Model: SP5		Date: 15-Oct-98	No.: 1
Modified Article: Parts Catalog		Prepared by: M. Tsuyuki	
From: GTS and S Field Information Dept.			
Reason for Modification:	☒ Parts catalog correction ☐ To facilitate assembly ☐ Part standardization	☐ Vendor change ☐ To improve reliability ☐ Other	☐ To meet standards ()

Model: SP5		Date: 31-Oct-98	No.: 2
Modified Article: Development Entrance Seal		Prepared by: A. Sasaki	
From: GTS and S Field Information Dept.			
Reason for Modification:	☐ Parts catalog correction ☐ To facilitate assembly ☐ Part standardization	☐ Vendor change ☒ To improve reliability ☐ Other	☐ To meet standards ()

Model: SP5/SP5L		Date: 15-Jan-99	No.: 5
Modified Article: Oil Supply Cleaning Roller		Prepared by: M.Tsuyuki	
From: GTSS Field Information Dept			
Reason for Modification:	☒ Parts catalog correction ☐ To facilitate assembly ☐ Part standardization	☐ Vendor change ☐ To improve reliability ☒ Other	☐ To meet standards ()

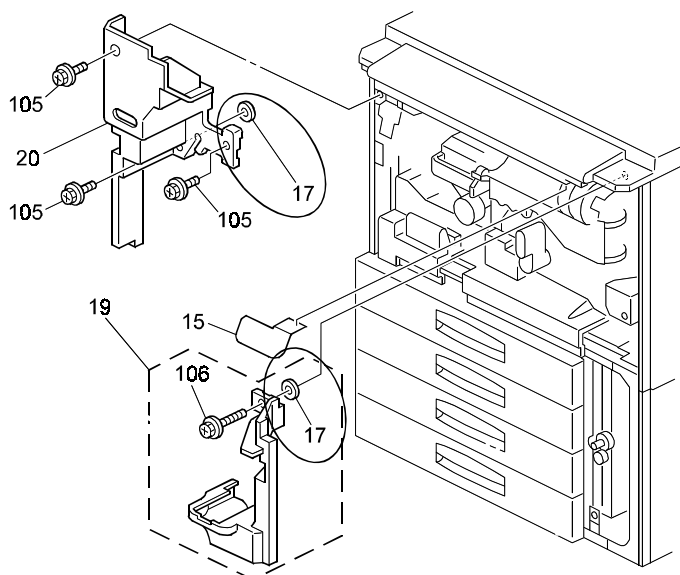
There are three index No.17 on page 14. Please delete two of these as shown in the illustration below.

42. Fusing Unit 1 (A229)

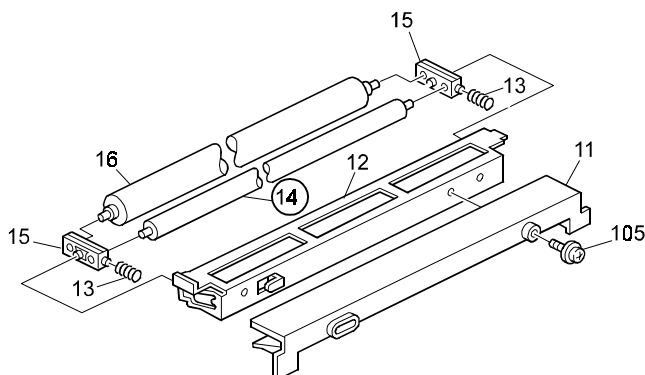
The oil supply cleaning roller has been modified from the first mass-production.

Reason for modification: In the morning, if the customer uses paper which contains a lot of calcium carbonate, black spots may appear on the first several copies.

Old part number	New part number	Description	Page	Index
AE042020	AE042035	Oil Supply Cleaning Roller	97	14

26. Paper Feed Unit 2 (A229)

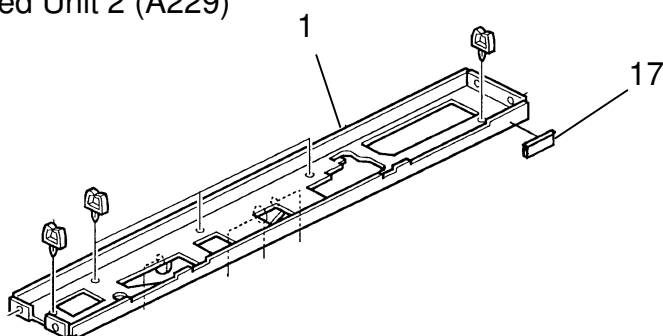
To minimize noise from the paper feed section when feeding paper, a cushion has been added as shown.

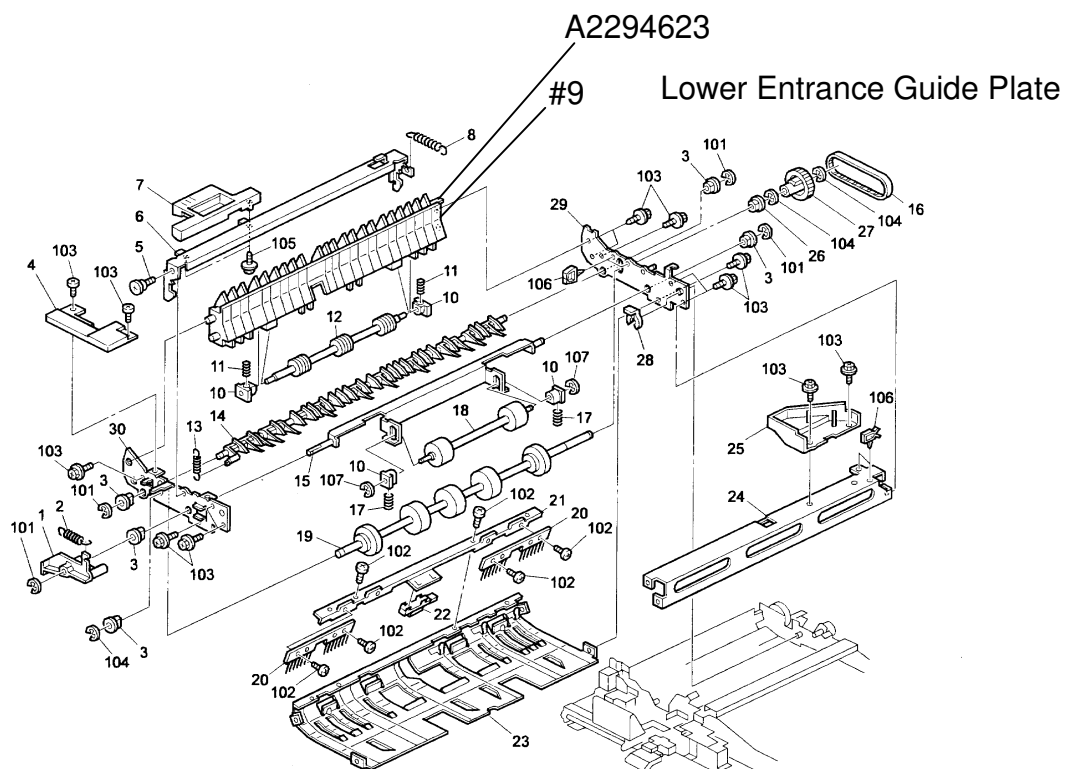
Index #9 on page 110 is missing. Please add it to your parts catalog as follows.

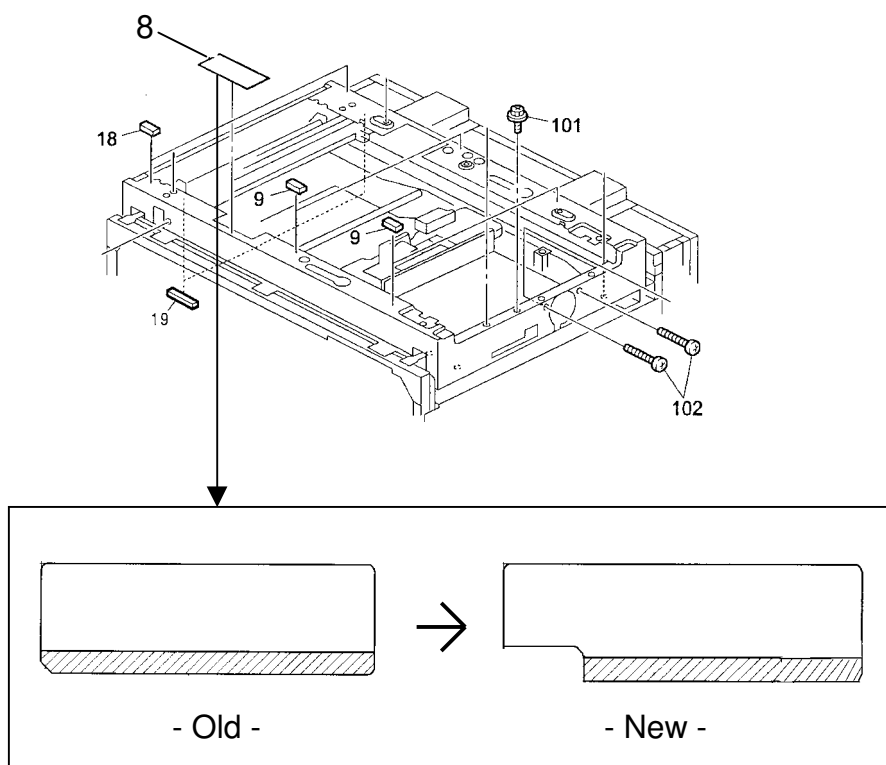
To prevent the bracket on the back of the operation panel from touching and pushing the seal, the shape of the seal has been changed as shown.

Old part number	New part number	Description	Q'ty	Int	Page	Index	Note
AA150636	AA150704	Seal – 90x29.5x0.2	1	X/O	41	8

2. Exterior 2 (A229)

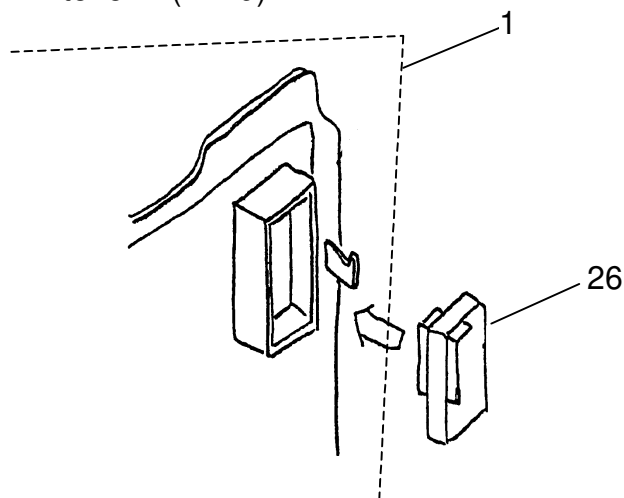
1. To meet the BAM new standards, an ozone filter has been added as shown.
(This is only for the A229-22, -26, -27, -62, -64, -65, -66, -67 models)
2. Two fan motors have been changed to ones with a lower noise level.

32.Toner Bottle Holder (A229)

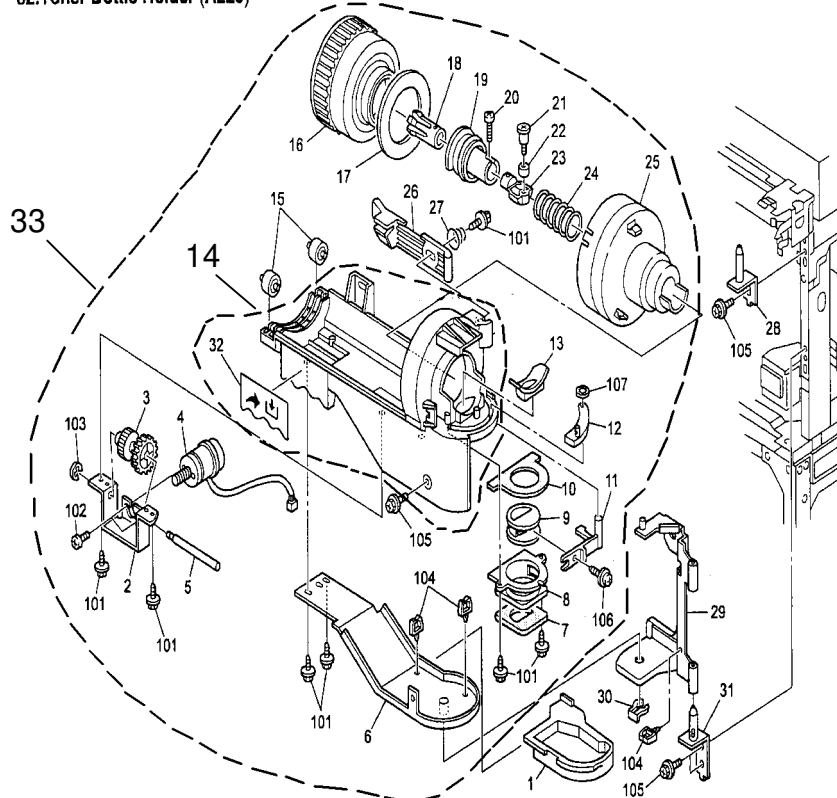
1. As per a field request, the Toner Bottle Holder Ass'y has been registered as a service part. Please refer to the illustration below for the component parts.
2. The illustration for Index 14 has been changed. The decal with Index 32 is included in Index 14. Please correct the parts catalog as shown.

Old part number	New part number	Description	Q'ty	Int	Page	Index	Note
	A229 3202	Toner Bottle Holder Ass'y (RIC LT)	1		77	33	*1
	A229 3203	Toner Bottle Holder Ass'y (RIC A4)	1		77	33	*1
	A229 3204	Toner Bottle Holder Ass'y (Others)	1		77	33	*1

19. By-pass Feed Unit (A229)

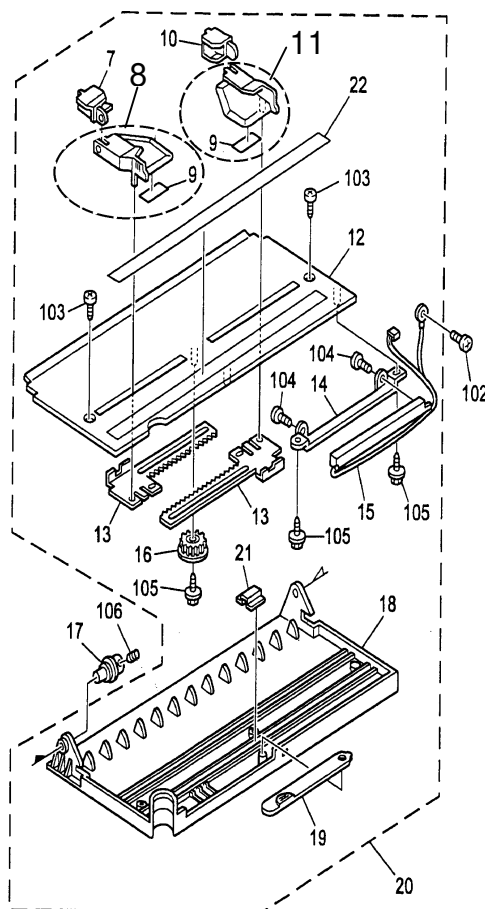
1. To minimize the possible noise generated when the side fences of the by-pass tray are opened, the width of the mylar seal has been enlarged from 16 mm to 26 mm.
2. The illustrations for Index 8 and 11 have been changed. The seal (Index 9) is included in Index 8 and 11. Please correct the parts catalog as shown.

Old part number	New part number	Description	Q'ty	Int	Page	Index	Note
A1762741	A2292866	Front Side Fence	1	X/O	51	8	
A0692645	A2292870	Seal – 0.2x165x47	2	X/O	51	9	
A1762751	A2292868	Rear Side Fence	1	X/O	51	11

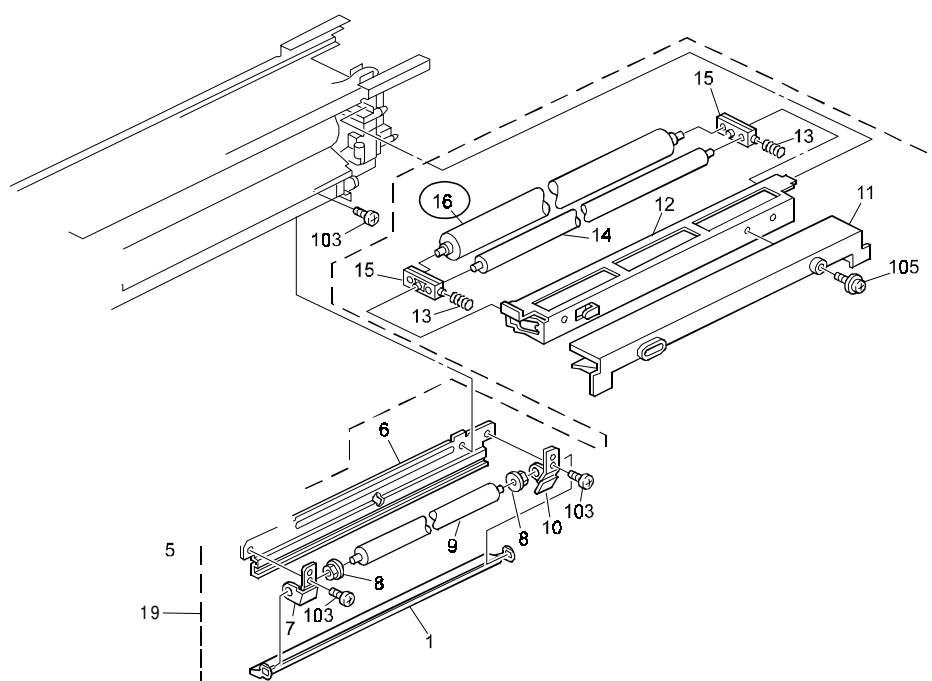
The oil supply roller has been changed to standardize the parts with current models (F401 series) as follows.

Old part number	New part number	Description	Q'ty	Int.	Page	Index
AE040023	AE040016	Oil Supply Roller	1	O/O	97	16

15. Optics Section 2 (A229)

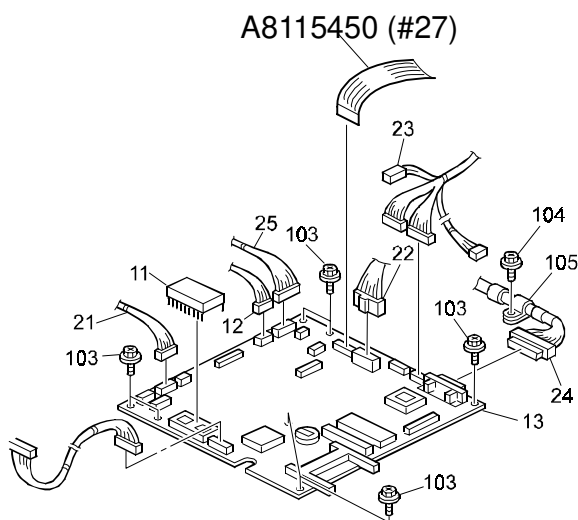
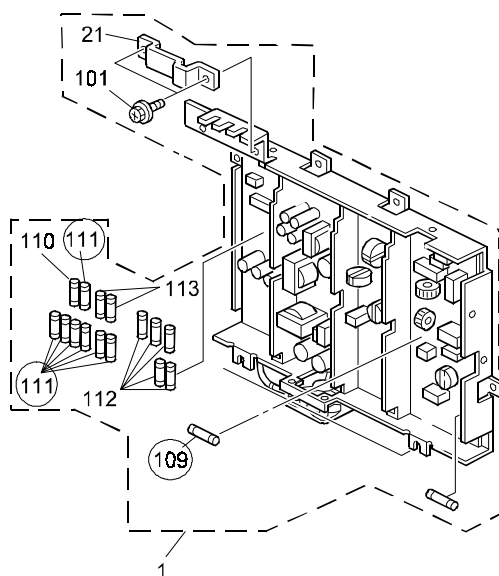
Item	Part number	Description	Page	Index
Missing	A8115450	Printer Harness	43	27(new)
Missing	11070880	Fuse - 6.3A 250V (230V)	131	109
Change	11070864	Fuse - 12A 250V -> Fuse - 12A 250V (115V)	131	109
Change	11070869	Fuse - 2A 125V -> Fuse - 6.3A 125V	131	111

3. Operation Panel (A229)

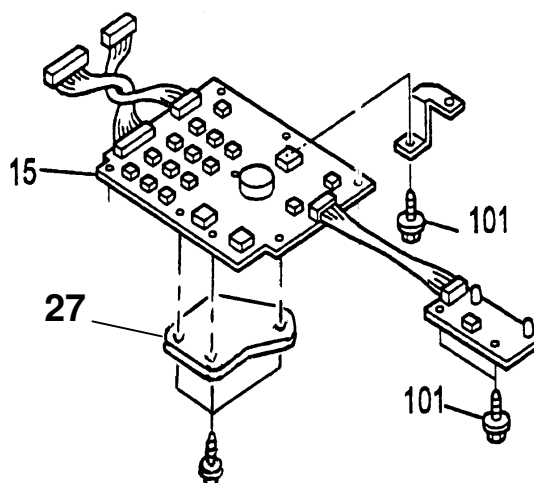
To support the 10-key Board, a support plate has been added under the board as shown.

Old part number	New part number	Description	Q'ty	Int	Page	Index	Note
	A2291472	Support Plate - Operation Panel	1		19	27	*1

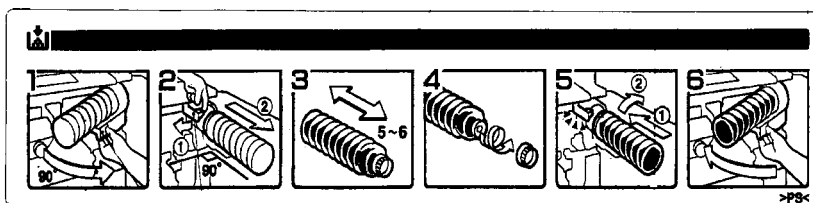
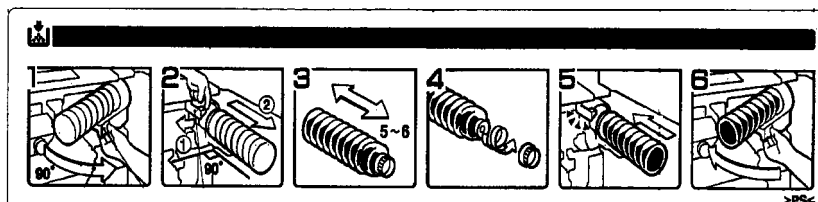
1. The material of the worm gear of the toner supply motor has been changed from resin to brass.
2. The thickness of the toner bottle bracket has been increased from 1.2 mm to 1.6 mm.
3. The length of the shaft has been extended from 50 mm to 51 mm.
4. Arrow mark #2 in Step 5 of the decal for the toner replacement has been deleted as shown.

Old part number	New part number	Description	Q'ty	Int	Page	Index	Note
A2293238	A2293248	Toner Bottle Bracket	1	X/O	77	2	
A2293240	A2293245	DC Motor	1	X/O	77	4	
AA145811	AA145817	Idler Shaft – Toner Bottle	1	X/O	77	5

46. Paper Exit unit 2 (A229)

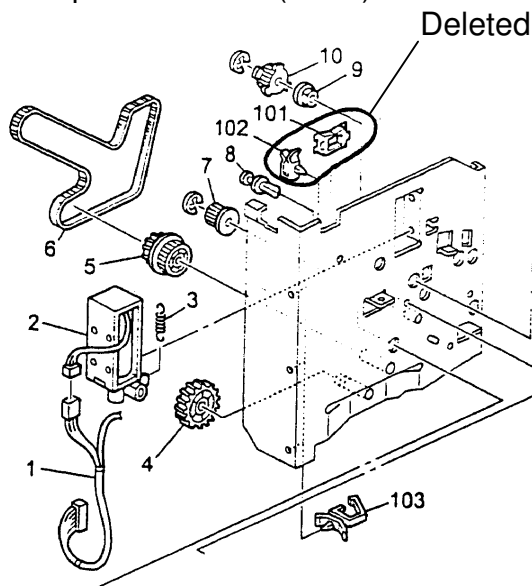
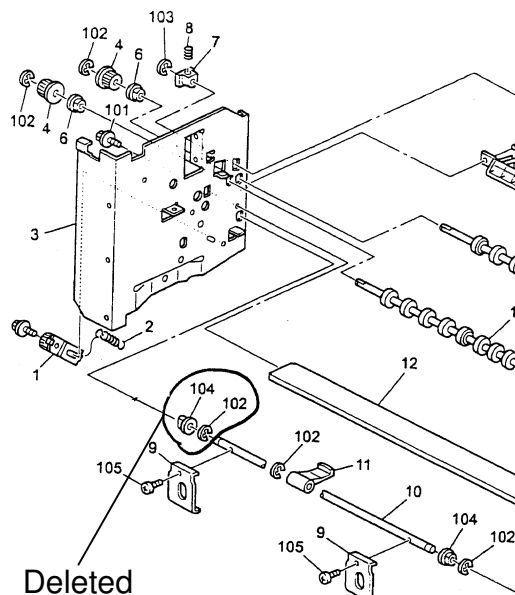
To standardize parts with a new model, the parts in the above table have been changed or deleted.

Please replace the Exit Rear Side Plate and Pressure Shaft together when one of the old types of these parts has to be replaced.

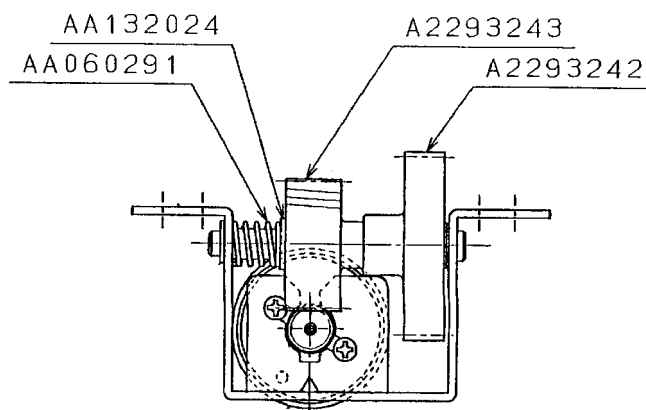
This is to inform about the second step of the modification in MB No. MA229020.

To prevent the gear from being damaged even if the toner bottle is turned clockwise when installed, a one-way mechanism has been added by using two gears.

Old part number	New part number	Description	Q'ty	Int	Page	Index	Note
AB01 7464		Connecting Gear	1		77	3	
	A229 3242	Toner Bottle Joint Gear	1		77	3	*1
	A229 3243	Motor Joint Gear	1		77	34	*1 *3
	AA06 0291	Spring	1		77	35	*1 *3
	AA13 2024	Spacer – M6	1		77	36	*1 *3
A229 3245	A2293240	DC Motor	1		77	4	*2

- *1: Please note that the two gears, the spring, and the spacer should be replaced at the same time.
- *2: It was informed in MB No. MA229020 that the material of the motor had been changed from resin to brass (the part number was changed from A2293240 to A2293245), but this modification had NOT actually been done due to difficulties with the motor production using brass. ***So as shown in the table above, the Motor P/N has been returned back to its previous number, i.e. from A2293245 back to → A2293240.***
- *3: New Index

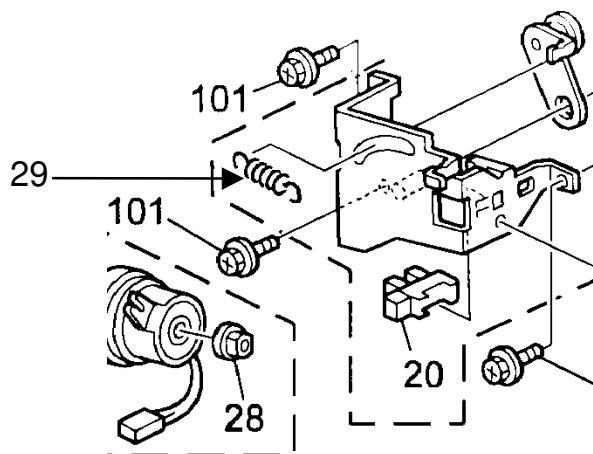
Please add the part in the above table to your parts catalog.

Old part number	New part number	Description	Q'ty	Int	Page	Index	Note
	AA06 0722	Tension Spring	1		123	29	*1

38. PCU 3 (A229)

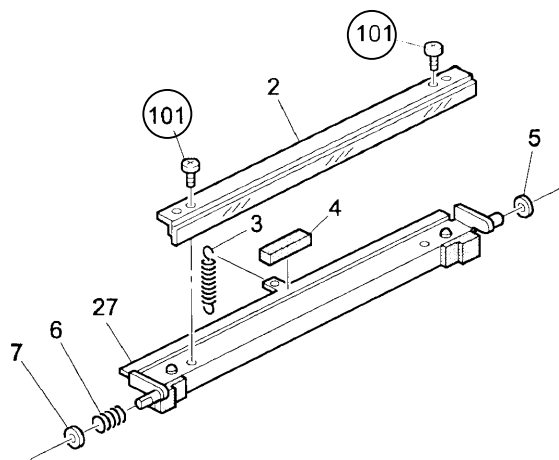
To standardize parts with a new model, the part in the above table has been changed.

Old part number	New part number	Description	Q'ty	Int	Page	Index	Note
0314 0060B		Philips Pan Head Screw – M4x6	2		89	101	
	0314 0040B	Philips Pan Head Screw – M4x4	2	O/O	89	101

< Machine Rear Side >

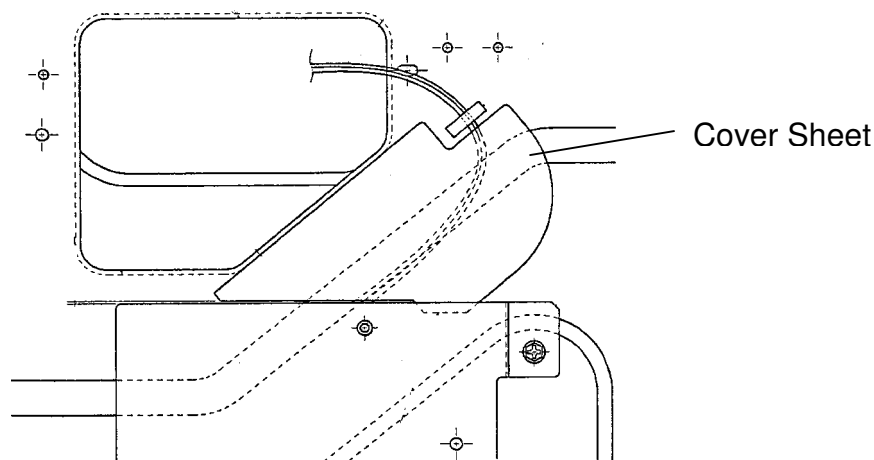
The harness for an anti-condensation heater may be damaged by the edge of the third tray when the third tray is inserted.

To prevent the damage, a sheet has been added to the base frame as shown below.

Old part number	New part number	Description	Q'ty	Int	Page	Index	Note
	A229 6080	Cover Sheet	1		139	34	*1

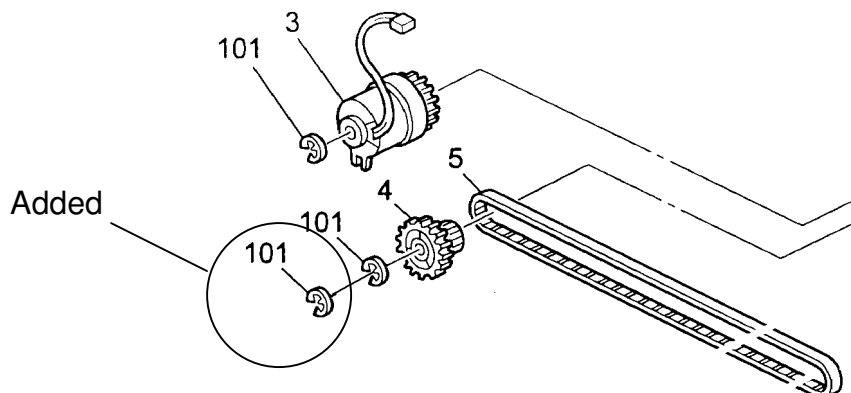
To minimize the play of the timing pulley gear (P/N AB01 7469) on the shaft, another retaining ring has been added, so the number of rings is now two.

Old part number	New part number	Description	Q'ty	Int	Page	Index	Note
0720 0040B	0720 0040B	Retaining Ring – M4	1-2		113	101

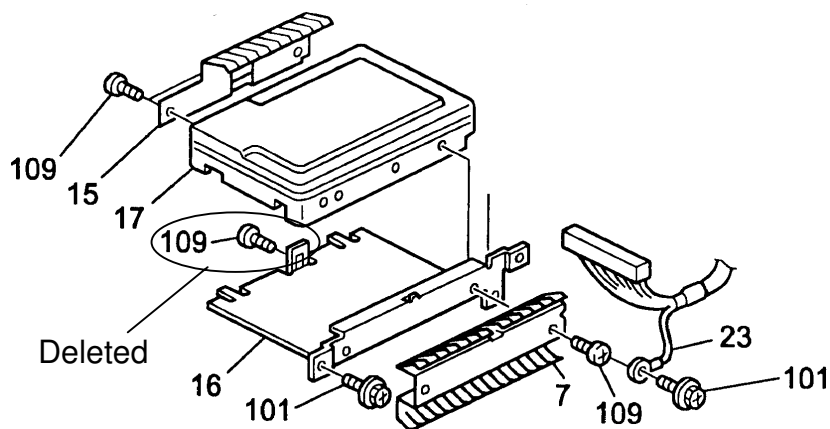
To facilitate assembly, one of the screws has been deleted as shown.

The shapes of the HDD Ground Plate and HDD Bracket have been changed. Please replace both of them at the same time if one of the old parts has to be replaced.

Old part number	New part number	Description	Q'ty	Int	Page	Index	Note
A2295897	A2295843	HDD Ground Plate	1	X/X	133	15	
A2295895	A2295842	HDD Bracket	1	X/X	133	16	
08010153		Bind Screw – M6x32	5-4		133	109

59. Electrical Section 2 (A229)

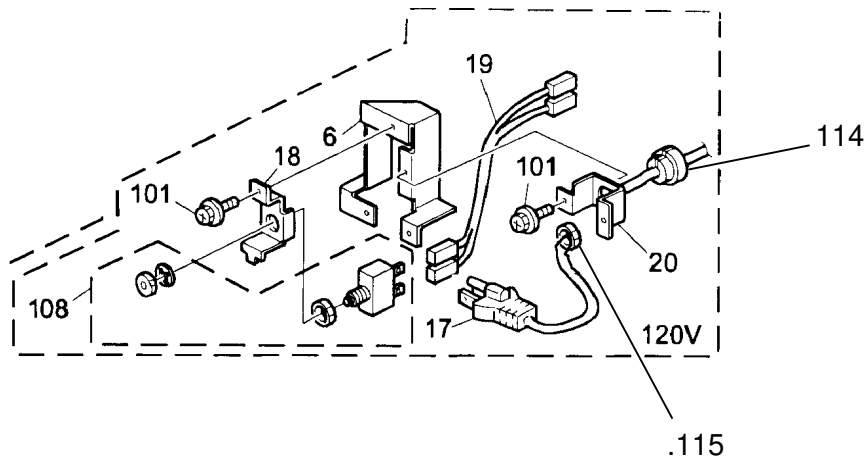
Please add the following parts to your parts catalog.

53.Drive Section 1 (A229)

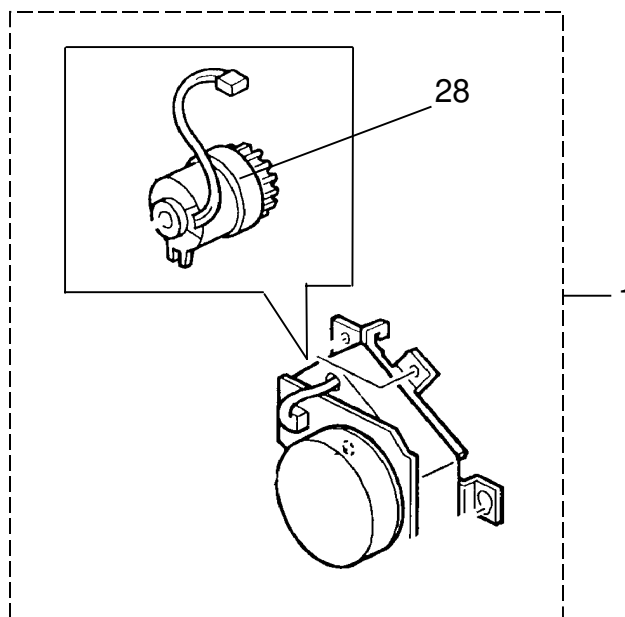
As per field request, the toner supply clutch has been registered as a service part.

26. Paper Feed Unit 2 (A229)

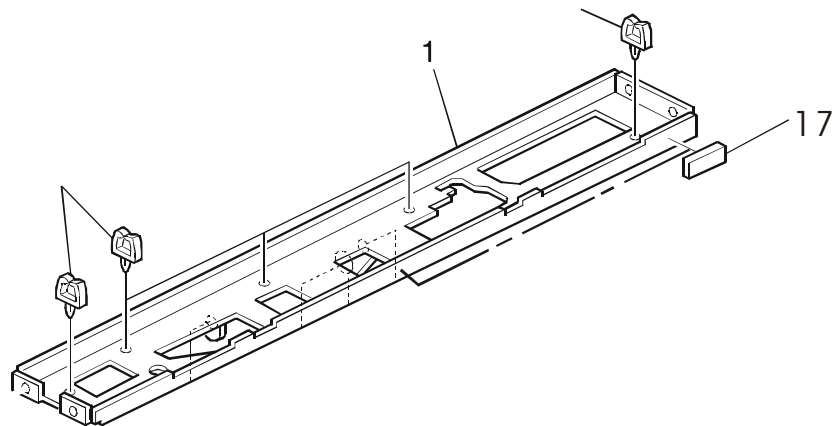
A cushion has been added to prevent noise from being generated by two metal parts due to vibration.

Old part number	New part number	Description	Q'ty	Int	Page	Index	Note
	5442 1924	Exposure Glass Cushion	1-2		65	17
